A303 Amesbury to Berwick Down

TR010025

**8.52.3 – Written summary of oral submissions put at
Flood risk, groundwater protection, geology
and land contamination hearing
on 29 August 2019**

**Written summary of oral submissions put at Flood risk,
groundwater protection, geology and land contamination hearing
on 29 August 2019**

Figure 5, Construction procedure for cross passages

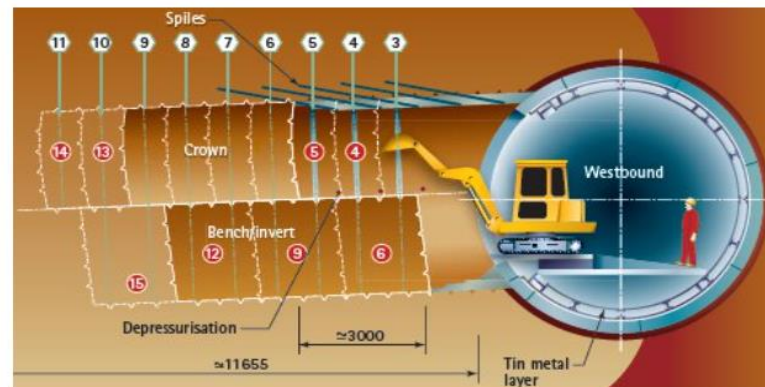
<p><i>consultation and approval to minimise dewatering and abstraction?</i></p>	<p>Mr Thomset, on behalf of the Environment Agency, indicated that they agree with the Applicant's position but request that closed face tunnelling should also be required for cross passages.</p> <p>Mrs Marie Ayliffe, on behalf of the Applicant explained why this is not appropriate:</p> <ul style="list-style-type: none"> • The current limitations with TBM technology, and particularly mini TBMs, will make it very difficult to build the cross-passages using a closed-face technique without adversely impacting and increasing the diameter of the main tunnel bore. The increase in diameter is as a direct result of the geometry and the flat surface required for starting the mini TBM drive and waterproofing connection between the two tunnels. • Irrespective of the geometry issue, the technology associated with mini TBMs is in the relatively early stages of development and to the Applicant's knowledge has only been used on one subsea tunnelling project in Hong Kong (Tsuen Mun Chep Lap Kok) where the increase in main tunnel diameter could be accommodated. The size of cross-passage required for emergency evacuation is also beyond the limit of what can be constructed by micro-tunnelling pipejacking. • Therefore the Applicant does not consider that it is practical to limit cross-passage construction to closed-face techniques as this is not supported by available technology. In addition, there is no closed-face tunnelling technology available to form the larger M&E plant rooms from the tunnel. • Traditional cross-passage construction relies on grouting a plug of ground from the main tunnel, excavation in stages with suitable ground support installed if required and local face depressurisation to effectively drain residual groundwater from the plug. It does not require wholesale dewatering and reduction of groundwater levels; the effects of face depressurisation are much more localised and of a much smaller scale. There should therefore be no concern that large scale dewatering could occur if closed face tunnelling is not mandated. • By way of example, the most relevant and recent cross-passage construction in chalk geology in the UK using traditional open-face methods is from Crossrail C310 North Woolwich to Plumstead under the River Thames as shown in the image below. • The twin 7.12m diameter 2.6km Thames Tunnels were driven under the River Thames at 10-12m cover. The site geology consists of the Chalk Group (Haven Brow Beds and Cuckmere Beds) with intermediate flint layers. The groundwater hydrology was controlled by two aquifer systems made up of the Upper Chalk and overlying floodplain Terrace Gravels, which are in hydrostatic contact and connected directly with the River Thames. As such, groundwater levels changed daily in response to the tidal motion of the River Thames with a variation of over 8m causing face pressure changes of approximately 0.8bar. Therefore the support pressure had to be constantly reviewed and adapted. • Construction of the cross-passages was undertaken using staged excavation and sprayed concrete lining techniques to reduce the permeability of the chalk and reduce water inflow. Fissure grouting was carried out for the two cross-

passages under the River Thames from the main tunnel bores. The success of grouting was proofed with probe drilling before the segments were removed. The slide shows the means of construction with support to the ground above the cross-passage tunnel using spiles, combined with local depressurisation of the excavated surface in conjunction with staged excavation and installation of a sprayed concrete lining to form the cross-passage. There was no need to dewater and indeed this would not have been possible considering the particular geology and hydrogeology at the location.

- The Applicant would therefore conclude that it is not appropriate to restrict cross-passage construction to closed-face technology which pushes at the boundaries of what is able to be achieved. Open-face techniques are available that satisfy the requirement to minimise dewatering and have been proven on other major infrastructure projects including Crossrail.
- In response to a comment from Wiltshire Council, it is also confirmed that providing for one form of technique within the OEMP would also not be appropriate - it would restrain flexibility for an issue that will need to be managed through the detailed design and construction process.
